COLORADO DIVISION OF RECLAMATION, MINING AND SAFETY
MINERALS PROGRAM INSPECTION REPORT
PHONE: (303) 866-3567

MINE NAME: Rough Cut Pit	MINE/PROSPECTING ID#: M-2001-033	MINERAL: Sand and gravel	COUNTY: Otero
INSPECTION TYPE: Monitoring	INSPECTOR(S): Amy Eschberger	INSP. DATE: January 13, 2016	INSP. TIME: 13:00
OPERATOR: Rough Cut, L.L.C.	OPERATOR REPRESENTATIVE: Keith Tucker	TYPE OF OPERATION: 112c - Construction Regular Operation

INSPECTION TOPIC: Gen. Compliance With Mine Plan

M2001-033 / Rough Cut Pit / Rough Cut L.L.C

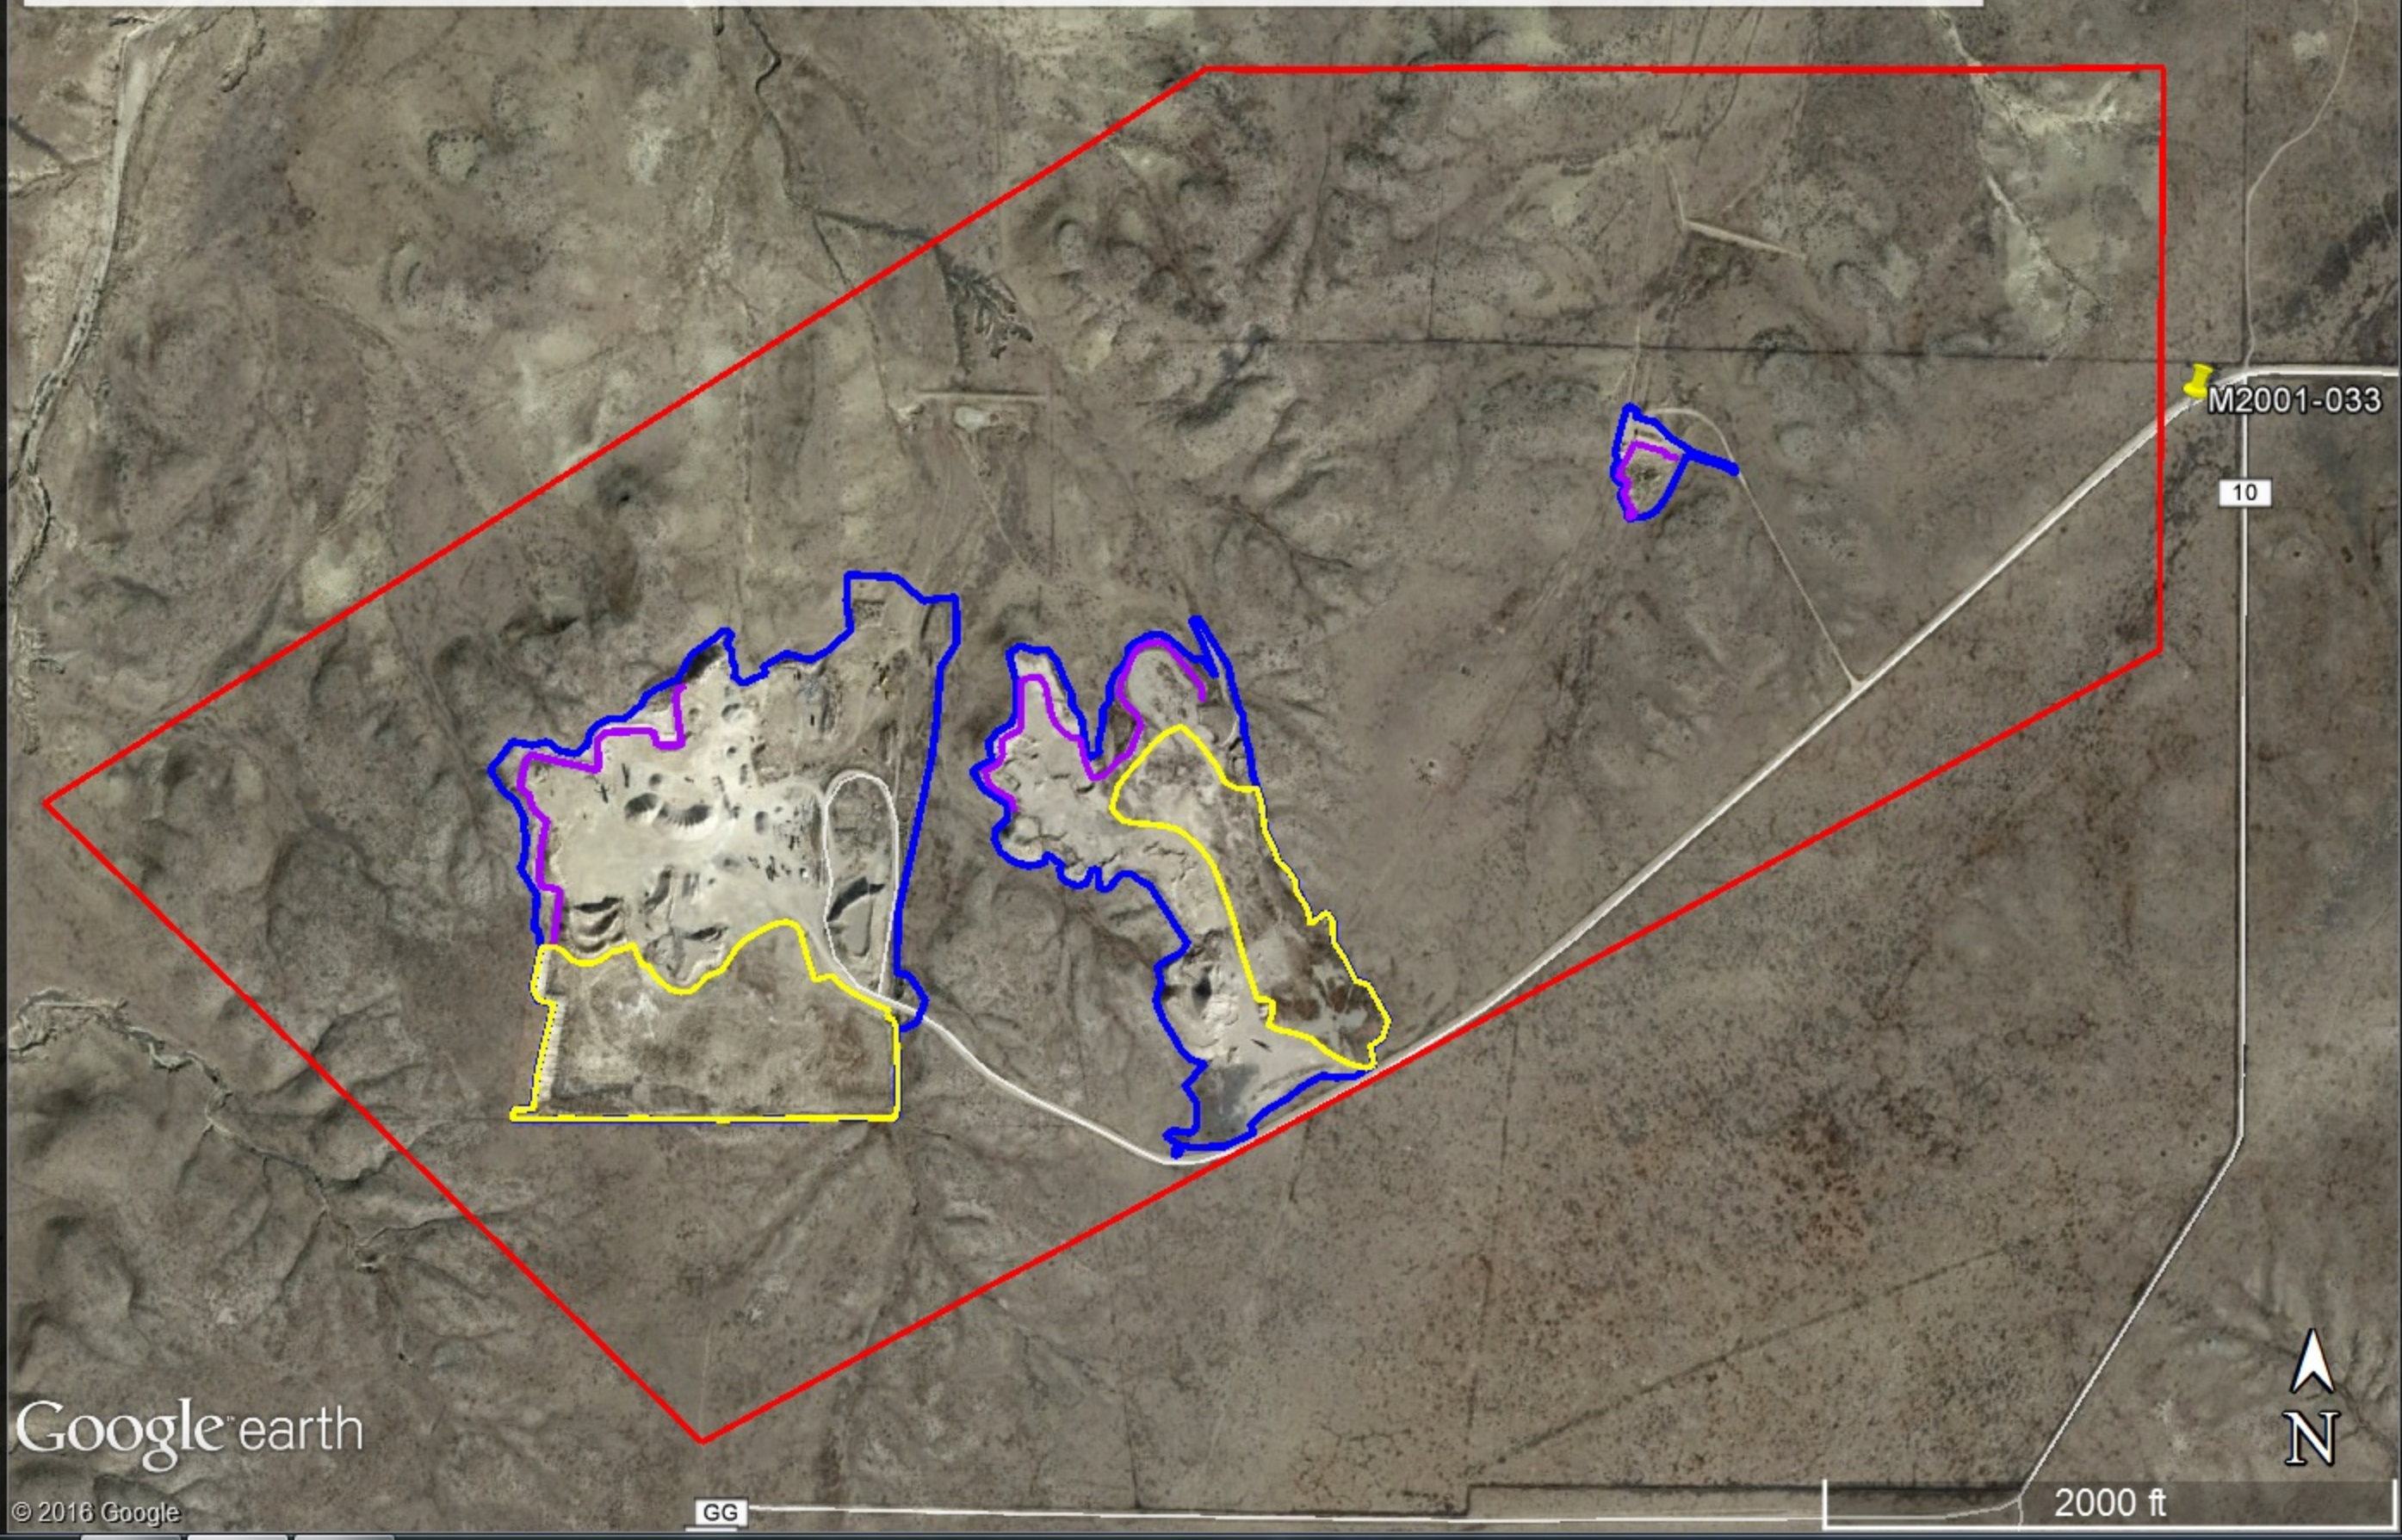
This is a 112c operation permitted for 467 acres to dry mine sand and gravel for construction use (**see enclosed aerial image of permit area**). The site is situated on an upland gravel terrace deposit where the operation will mine the ridge tops. The approved maximum mining depth is 35 feet. The approved mining plan includes five mining phases, with phase 1 operations beginning near the center of the site (**see enclosed approved mining plan map**). Mining will proceed generally eastward throughout the permit area, then will finish off in phase 4 located in the far western portion of the permit area. Material processing will occur on site using mobile crushing and screening equipment.

Including all three phases mined thus far, the Division estimates that the operation has disturbed a total of approximately 75.7 acres, which is more than the approved maximum allowed disturbance of 45 acres. The Division estimates that a total of 23.25 acres are in reclamation, which would leave 52.45 acres of disturbance that are not in reclamation. The Division understands this is a phased mining operation that wishes to maintain a floating bond. This means that the Division will not include disturbed land that has been graded, retopsoiled and seeded in the maximum allowed disturbed area. However, until the reclaimed areas have a well-established vegetative cover consistent with the approved reclamation plan, the Division must continue to hold a portion of the required bond for revegetating these areas. **A problem is being cited in this report (see page 1) for**

CORRECTIVE ACTIONS: The operator shall submit a Technical Revision, with the required \$216 revision fee, to update and clarify the current approved mine plan to reflect existing and proposed activities by the corrective action date. Specifically, the operator shall increase the maximum allowed disturbed area to at least 53 acres to account for existing disturbance.

M2001-033 / Rough Cut Pit / Rough Cut L.L.C

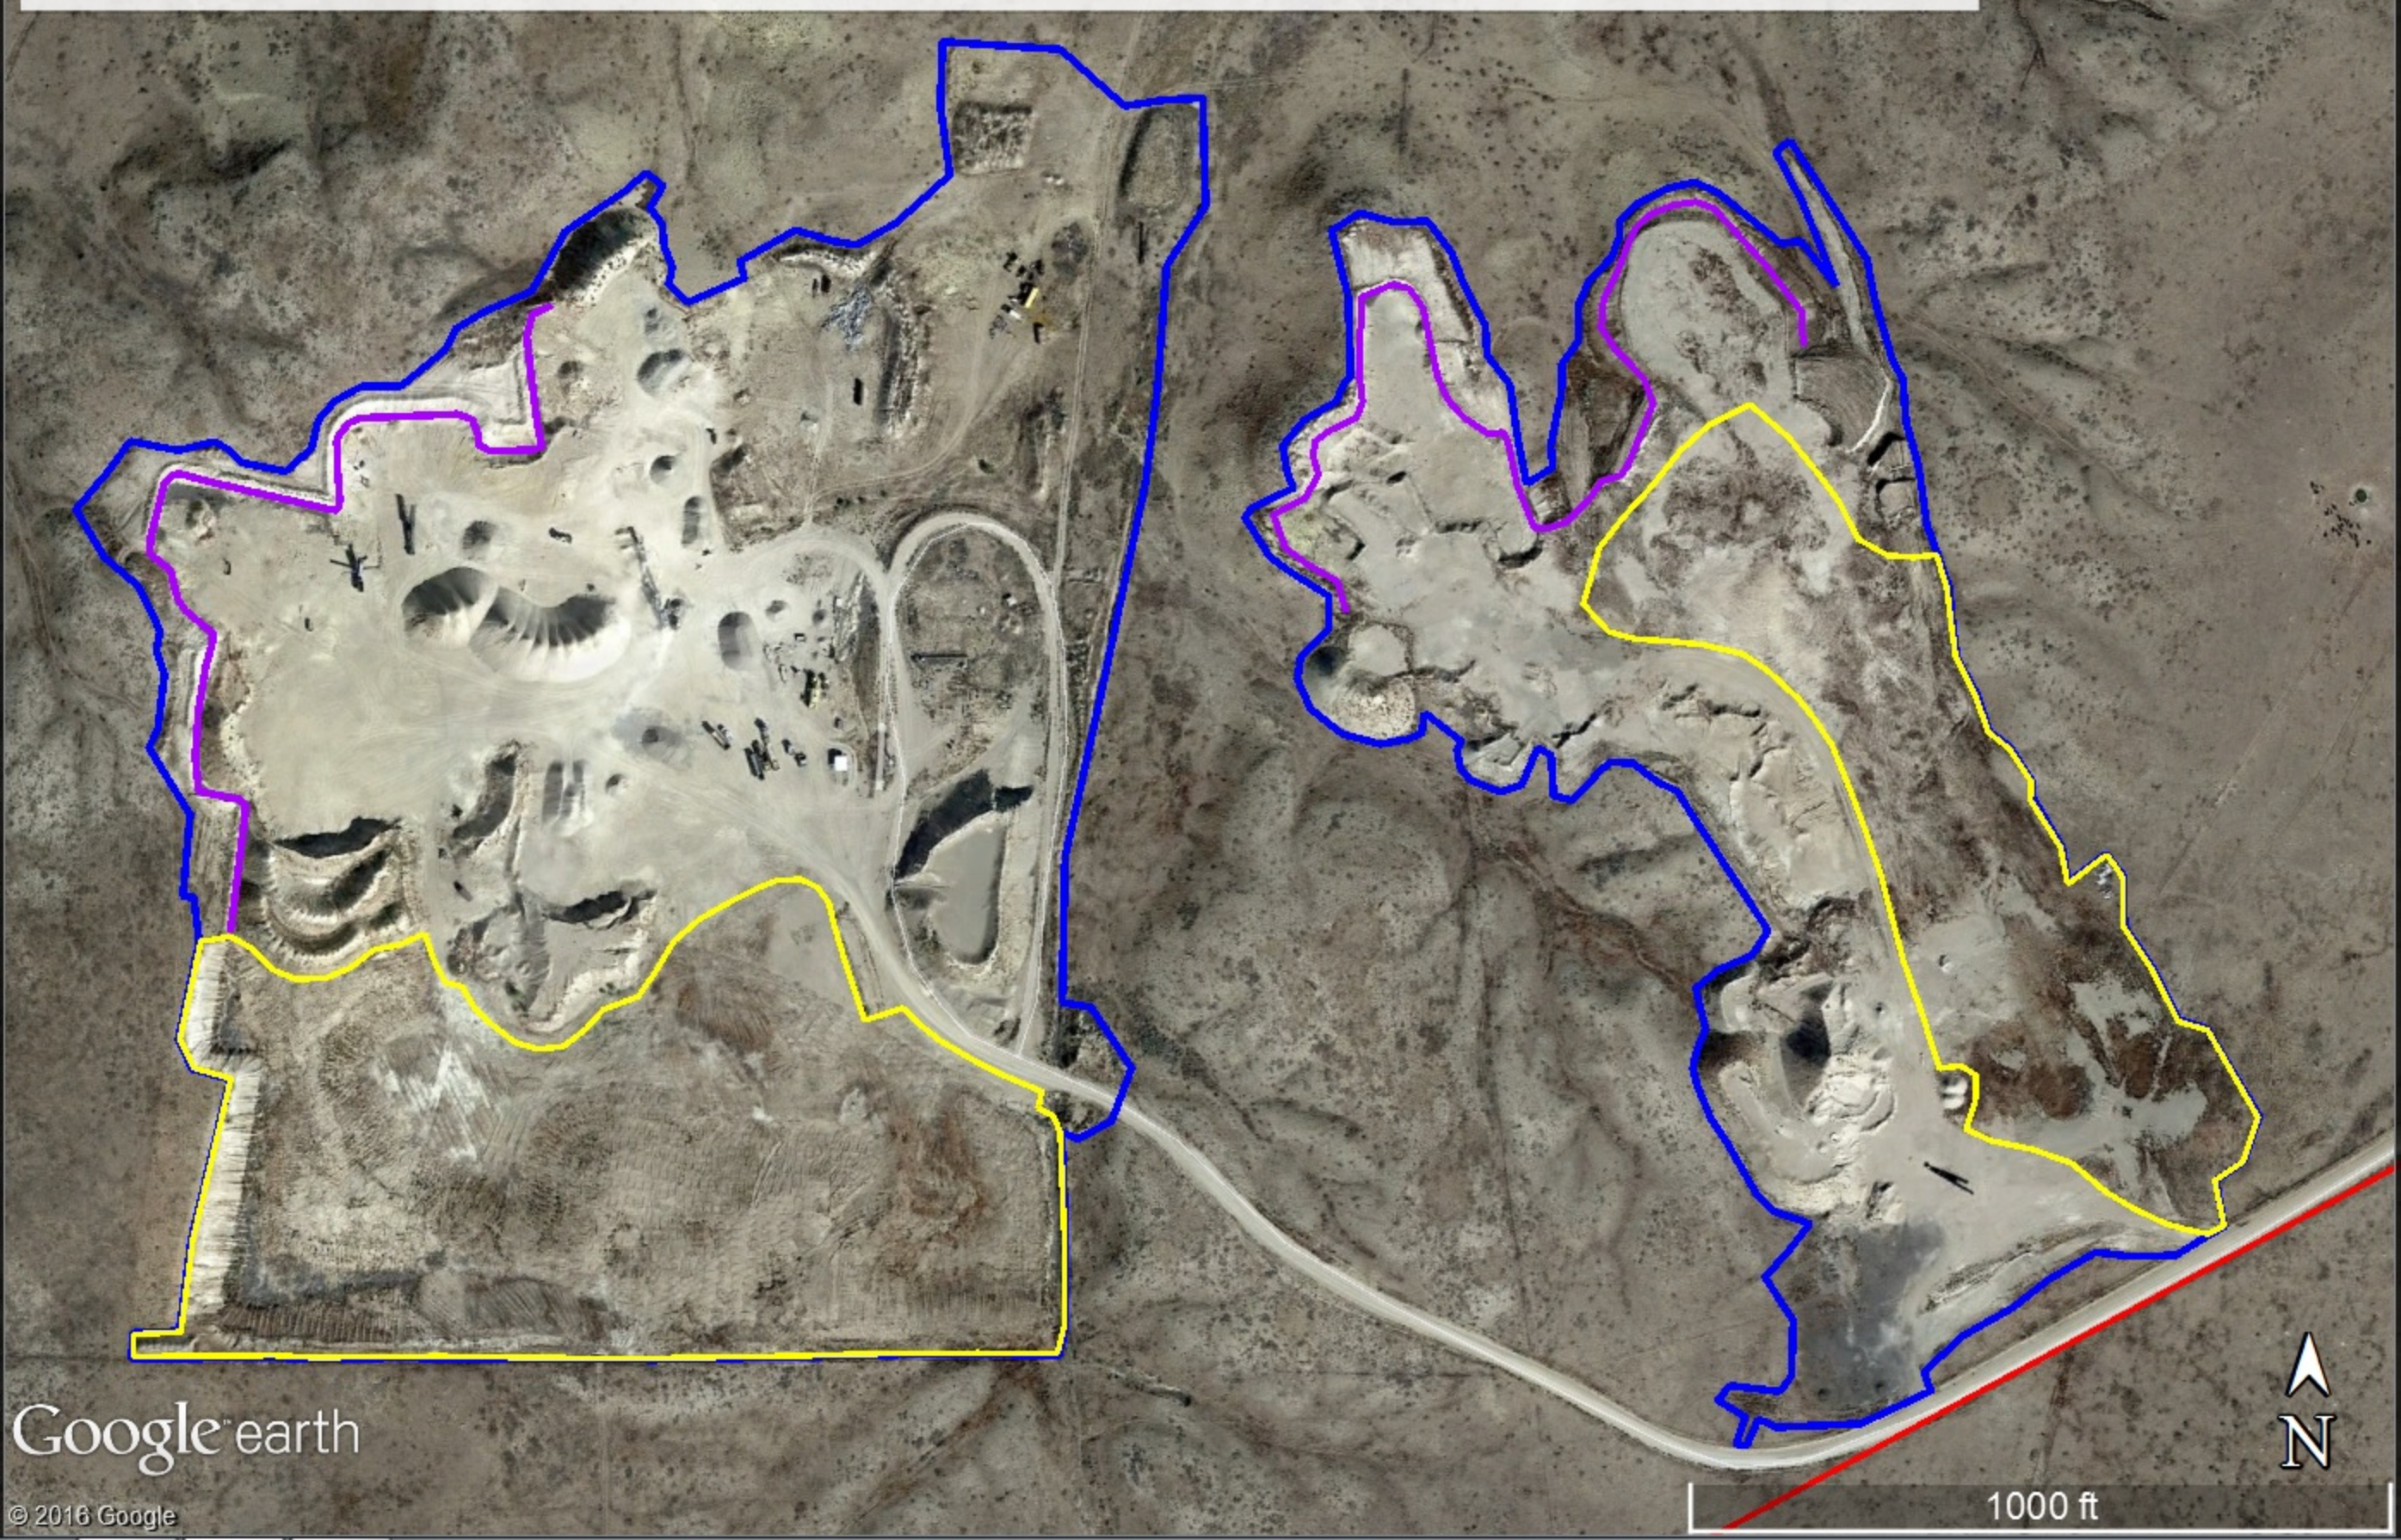
Next, the Division observed the phase 2 mining area that is located east of the phase 1 area. The phase 2 mining area was not active during the inspection, and no equipment was stored in this area. Disturbance in this area covers approximately 26 acres, and includes an area on the southern end where the small batch plant operated in 2012 (**Photo 20**), several material stockpiles of various shapes and sizes along the western edge (**Photos 21-23**), a mined wall along the northern edge of the pit, topsoil stockpiles in the northeastern portion, and a previously disturbed area along the eastern edge that is in reclamation. The topsoil stockpiles appeared to be stable with some vegetative cover. The mined wall ranged from approximately 5 feet to 15 feet in height with near vertical slope gradients (**Photos 24-26**). The Division estimates the length of the mined wall in this area to be approximately 1,947 feet. The operation appears to be expanding the pit to the north, following the gravel ridges. The operation moved into the phase 2 area in 2012. However, there has not been much activity in this area since the batch plant was moved out that same year.

noncompliance with the approved mining plan by disturbing more than the approved maximum allowed disturbed area of 45 acres. The corrective action includes submitting a Technical Revision to increase the maximum allowed disturbed area at any time to at least 53 acres (to include current disturbed land not in reclamation). A Technical Revision cover sheet is enclosed with this report. The Division recommends the operator include in the disturbance increase any additional acres that may be disturbed in the following year. In review of the Technical Revision, the Division will need to reassess the required financial warranty. The operator should be aware that a request for surety reduction may be submitted at any time to account for disturbed land that has been reclaimed and will not be redisturbed by the operation.
